# UNITED STATES PATENT AND TRADEMARK OFFICE

APPLICATION NO.	FILING DATE	FIRST NAMED INVENTOR	ATTORNEY DOCKET NO.	CONFIRMATION NO.
10/539,581	06/17/2005	Seong-Yeol Hyeon	0630-2353PUS1	4329
2292	7590	06/16/2008	EXAMINER	
BIRCH STEWART KOLASCH & BIRCH			KRAMER, DEVON C	
PO BOX 747				
FALLS CHURCH, VA 22040-0747				
		ART UNIT	PAPER NUMBER	
		3746		
		NOTIFICATION DATE	DELIVERY MODE	
		06/16/2008	ELECTRONIC

<b>Office Action Summary</b>	<b>Application No.</b>	<b>Applicant(s)</b>	
	10/539,581	HYEON, SEONG-YEOL	
	<b>Examiner</b>	<b>Art Unit</b>	
	DEVON C. KRAMER	3746

## DETAILED ACTION

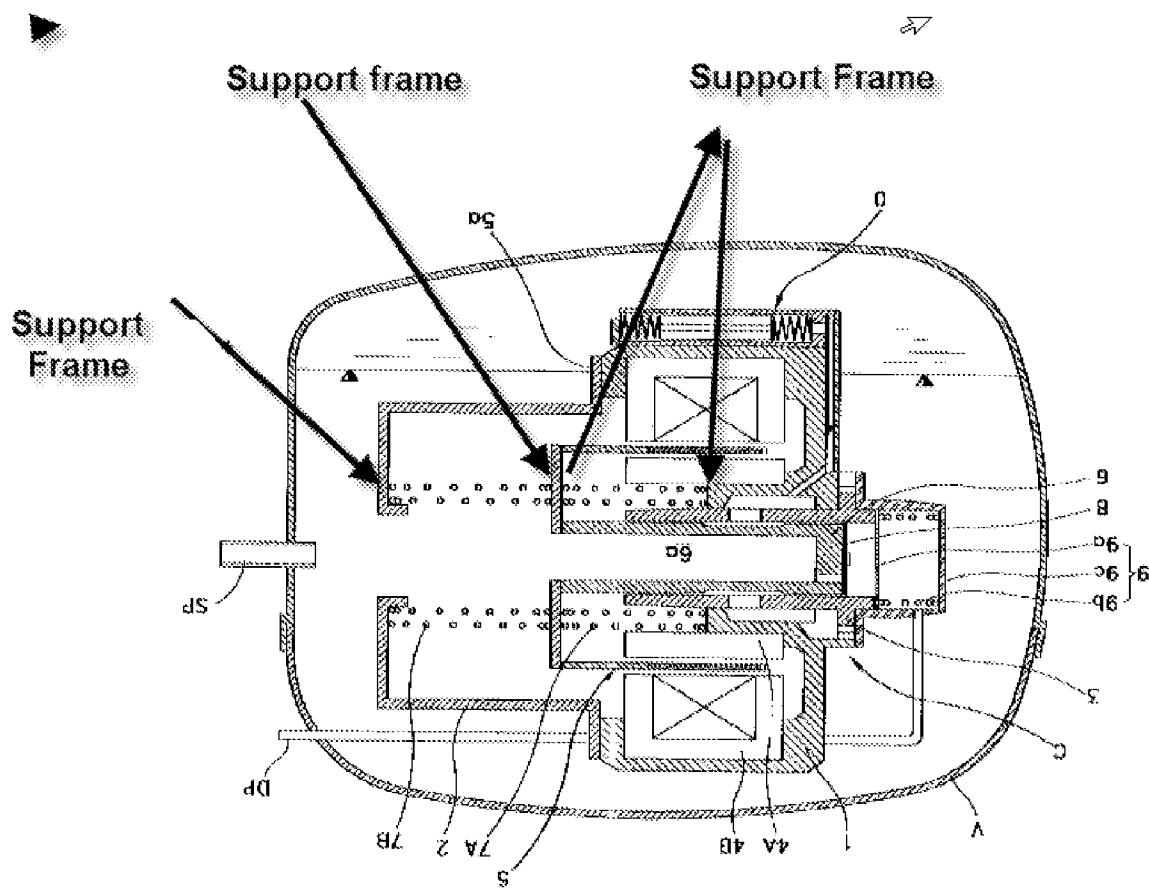
Claim 1 is rejected under 35 U.S.C. 102(b) as being anticipated by Song (6435842).

Song teaches reciprocating compressor comprising: a reciprocating motor (4a, 4b) disposed in a casing, and configured to generate a driving force (col. 1 lines 63-67); a compression unit C configured to suck, compress, and discharge gas by the driving force of the reciprocating motor; a resonant spring unit (7A, 7B or 20a, 20b) configured to provide a reciprocating movement of the reciprocating motor with a resonant movement; and at least two spring supporting frames (2, 5a or 2, 13b) configured to support the resonant spring unit, wherein one of the spring supporting frames is inserted into another of the spring supporting frames. Please note that frames 13b and 5a are within frame 2.

**Frame Support**

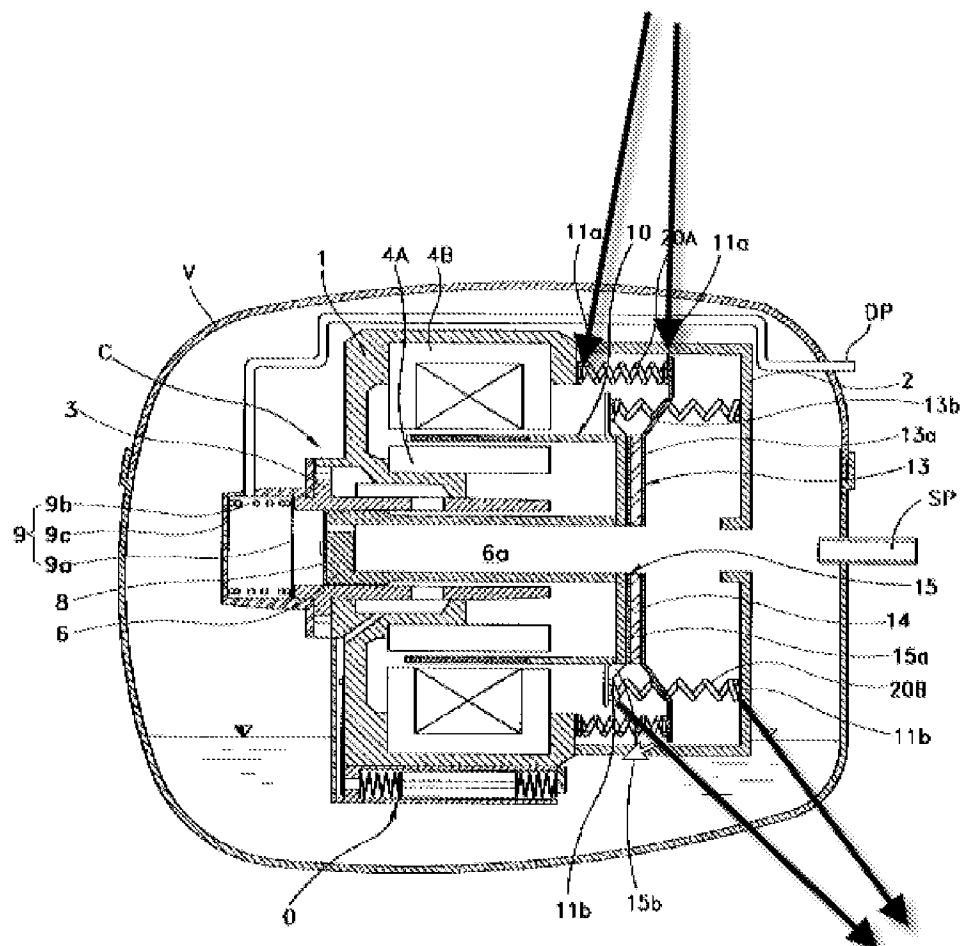
Applicant's arguments filed 2/29/08 have been fully considered but they are not persuasive. Applicant states that Song lacks the teaching of one supporting frames inserted into another of the supporting frames. Please note that the examiner has interpreted the reference of Song as containing 4 frames and some of the frames are surrounded or inserted into other frames as seen in the figures above.
